Memo

To:	Rachel Morgan	Job No:	1003297.6000
From:	Justine Quinn	Date:	24 March 2020
cc:	Nick Carter, Gary Bramley		
Subject:	Drury East Plan Changes - Ecology Response

Figure 1.1: Marine SEA in the Pahurehure Inlet and wider Drury Creek estuarine area

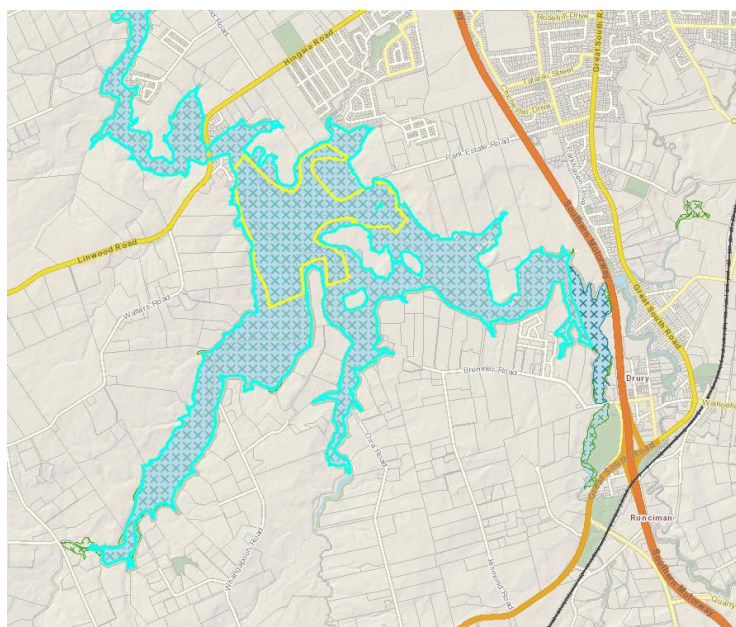
The following response has been prepared in relation to RFI E10 (Kiwi), E11 + E12 (Fulton Hogan), E10 + E11 (Oyster) which collectively request that more information is provided to assess the effects of sediment and erosion on the life supporting capacity of the marine significant ecological area.

The marine receiving environment is the Drury Creek and wider Pahurehure Inlet. The immediate marine environment is recognised as a Significant Ecological Area (SEA), which includes SEA-M1_29a, SEA-M2_29b and SEA-M2_29w1-2, shown on Figure 1.1.

Immediately adjacent to State Highway One, the intertidal area is classified as an 'SEA-M1' indicating that its physical form, scale or inherent values are considered to be the most vulnerable to any adverse effects of inappropriate subdivision, use and development. The AUP OP identifies that within these upper tidal reaches of Drury Creek there are a variety of marshes, grading from mangroves through to extensive areas of jointed rush-dominated saltmarsh, to freshwater vegetation in response to salinity changes. This same area is a migration pathway between the marine and freshwater environments for a number of native diadromous freshwater fish species.

Beyond this, the wider intertidal area is classified as an 'SEA-M2' being an area of regional, national or international significance which does not warrant a SEA-M1 identification as they are generally more robust. This has similar ecological values, but also provides roost areas of importance to wading birds including pied stilt.
